UNITED STATES PATENT AND TRADEMARK OFFICE

Office Action Summary	Application No. 10/542,350	Applicant(s) ABADIE ET AL.	
	Examiner TINA NGUYEN	Art Unit 3739

DETAILED ACTION

1. This is a final Office Action in response to amendment filed by applicant on January 13, 2010.

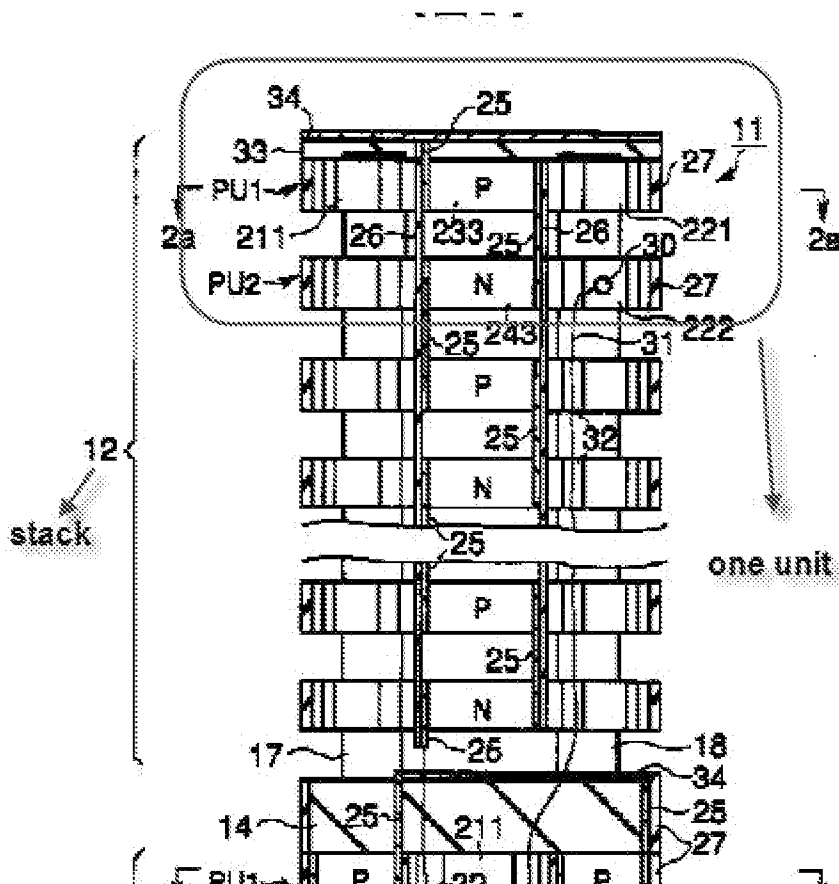
11. As to claim **36**, Maruyama et al. disclose a stack of orientable longitudinal structures having the claimed limitations as explained in the rejection of claim 17 above (Fig. 1, see Figure below for clarification), each one being identical and electrically

connected to a previous one. The stack has a possibility of orientation about the longitudinal axis of the stack.
